REQUEST FOR PROPOSALS
UK-2564.0-13-25
HEB – EARLY EQUIPMENT PURCHASES
ADDENDUM #2
09/30/2024

CCK-2564.0-13-25
Question and Response Log
Question Deadline

SECTION 23 0240- HVAC EQUIPMENT - AIR HANDLING UNITS

M-212E

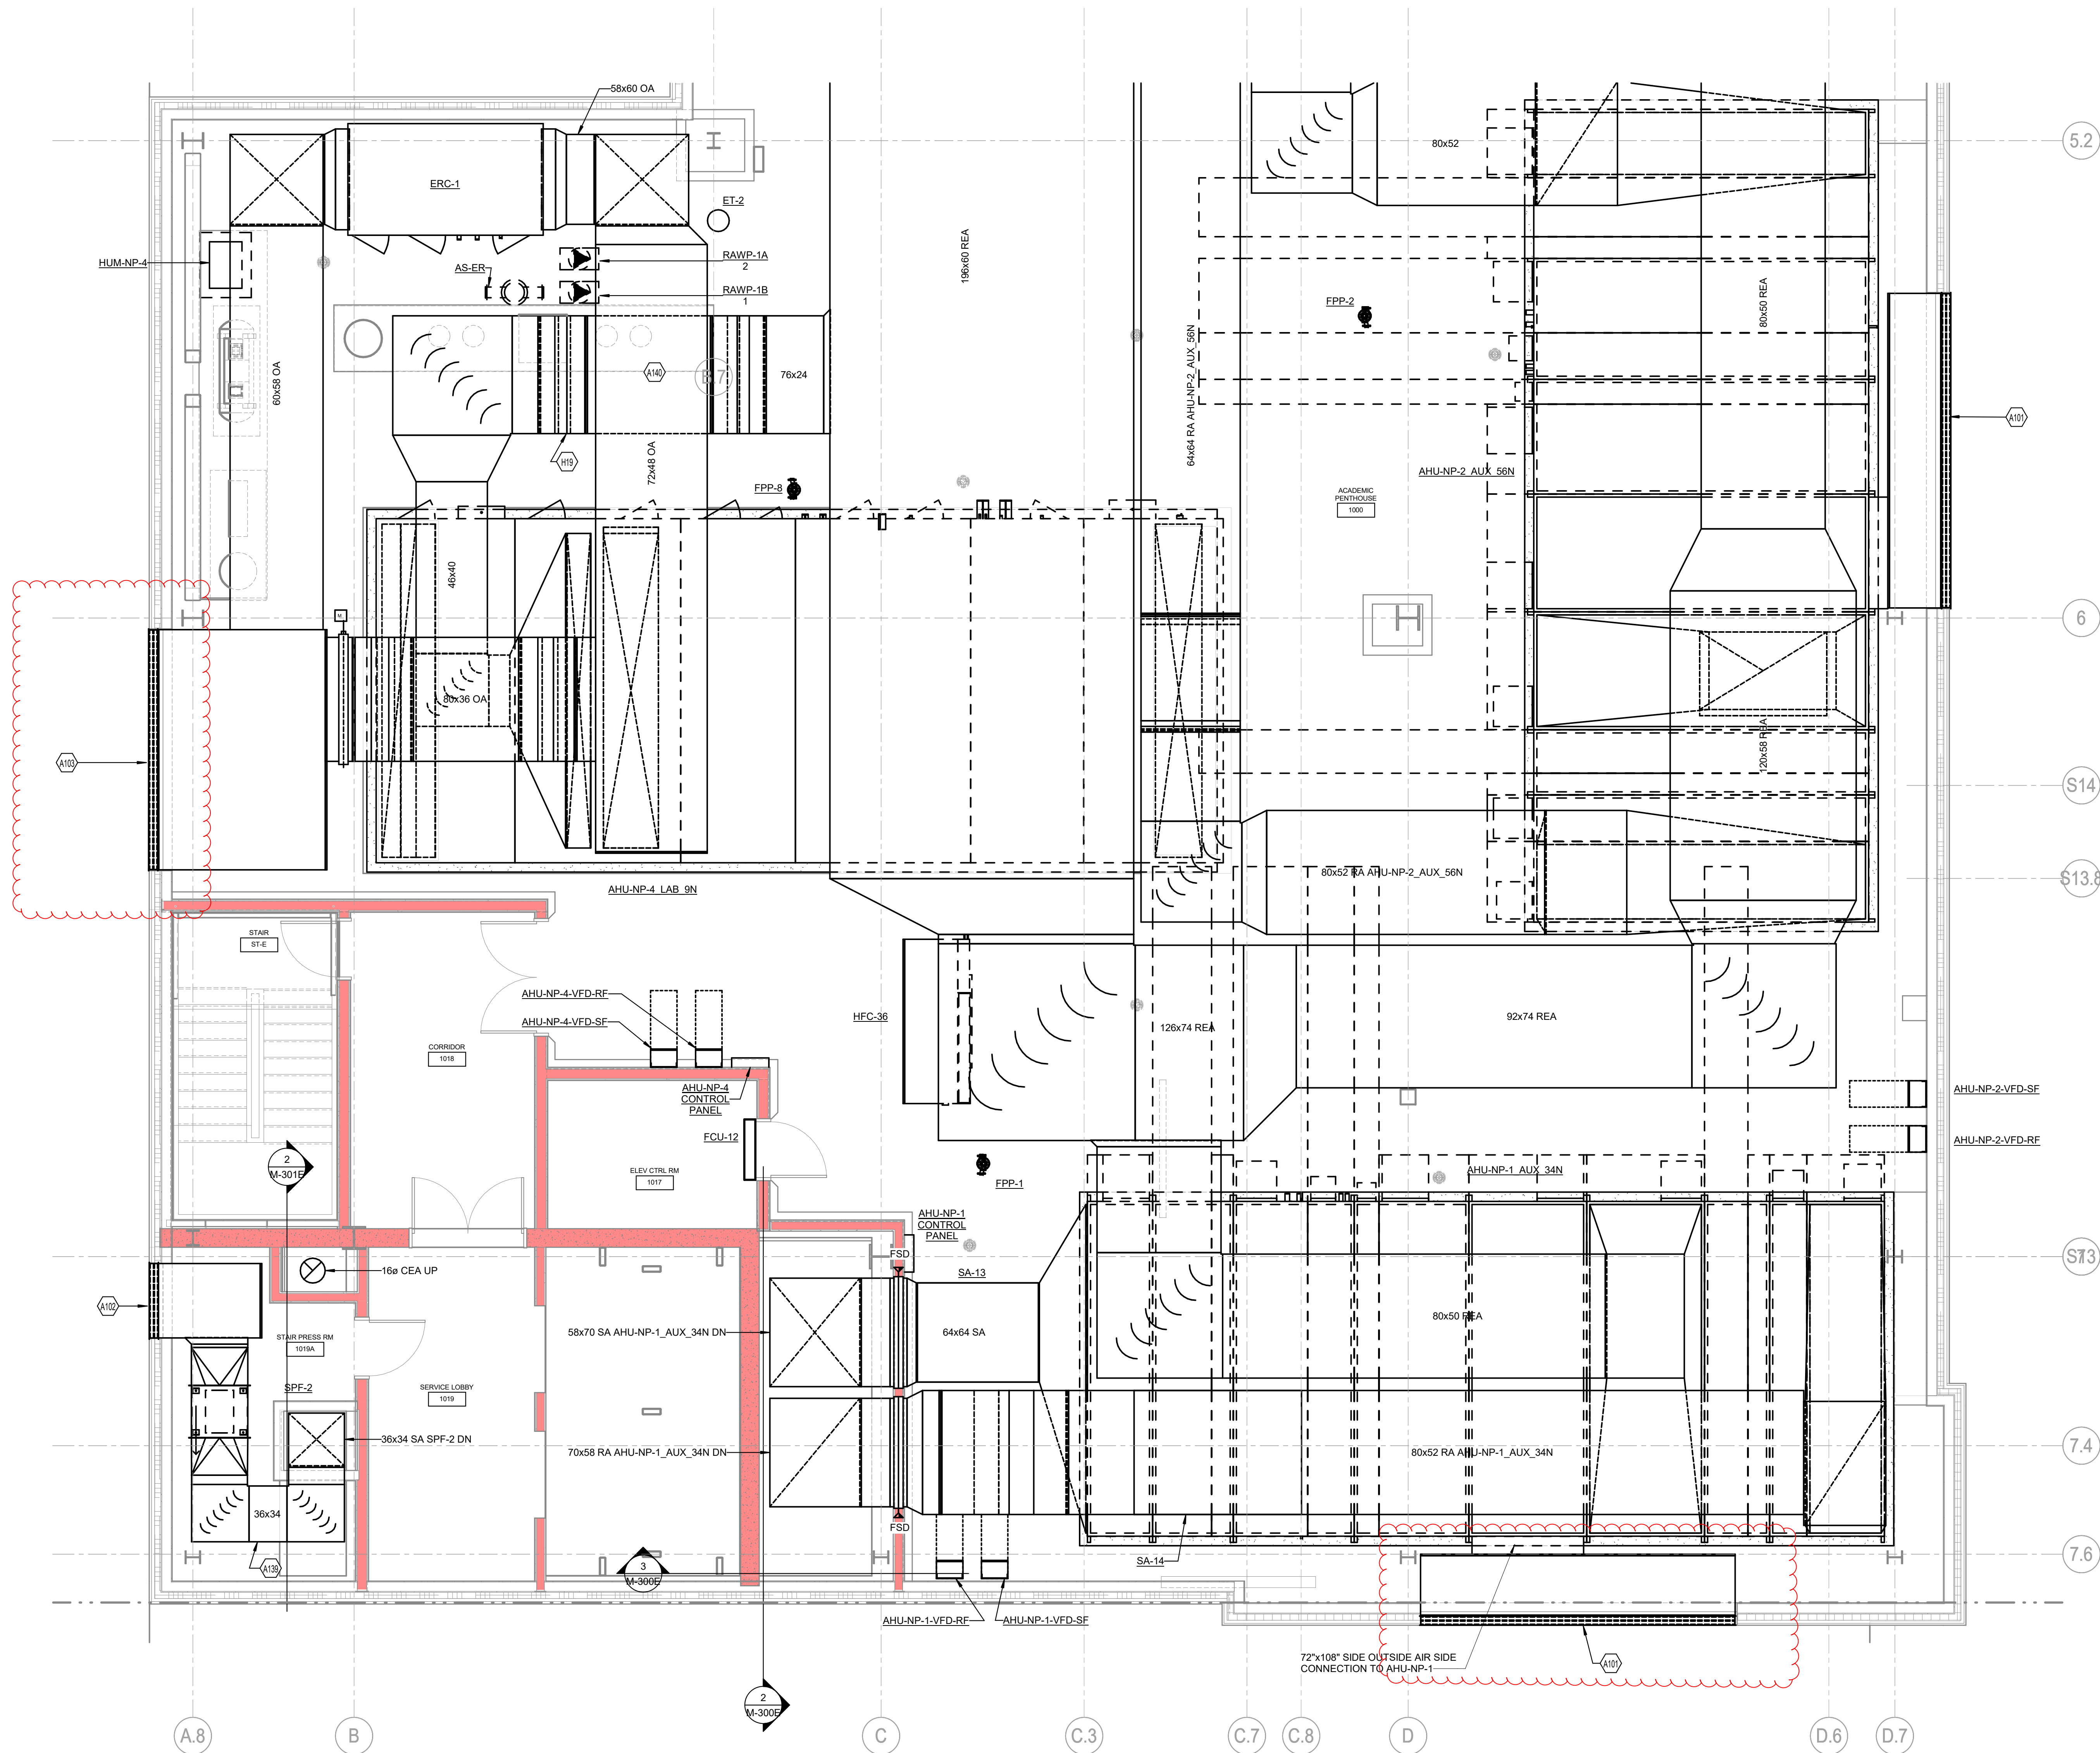
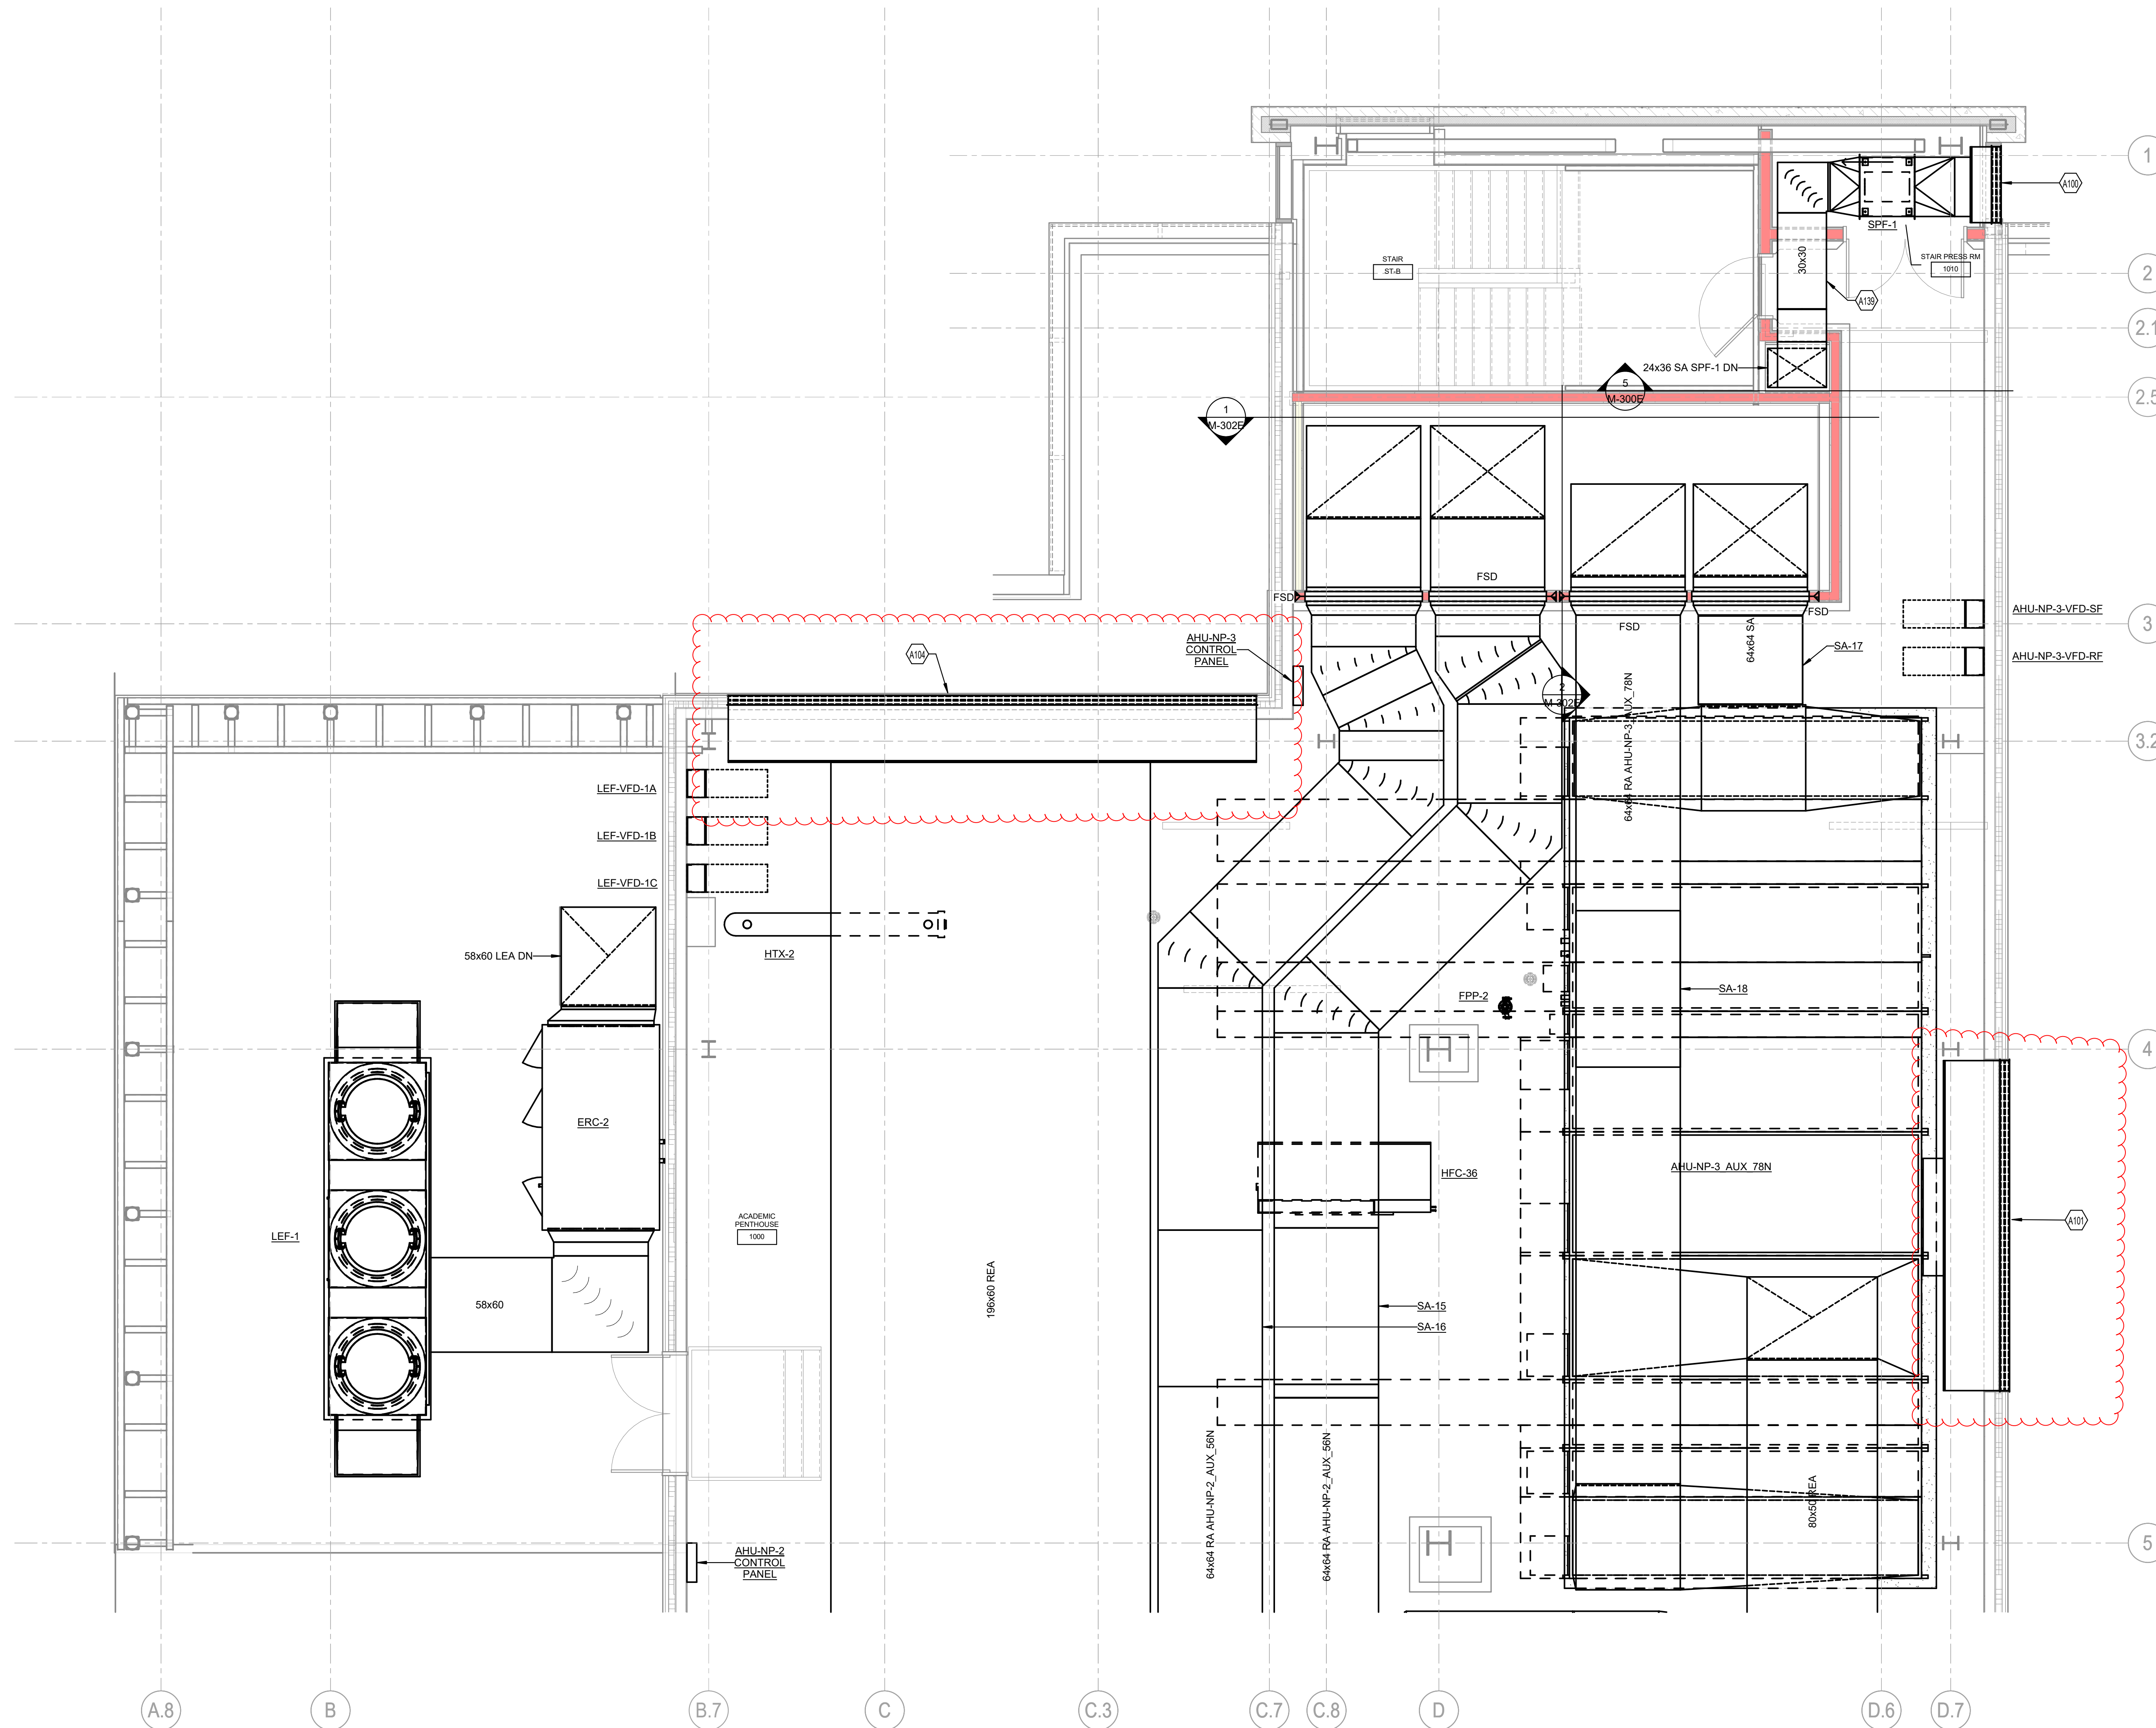
11	For rigging, are there any size/section limitations either dimensionally or weight-wise?	Refer to the attached drawings. These are provided for reference only and indicate the size of the louvers that are provided to allow AHU's to be brought into the Penthouse and Mechanical Room.
12	Are all AHU's going to be able to be rigged into building in sections? Or will knock-down be required? If knock-down, please advise which units and what the rigging pinch point is.	It is the design intent to provide all modular AHU's with no knock-down units. The unit shipping splits shall be sized such that they can fit through the building louvers.
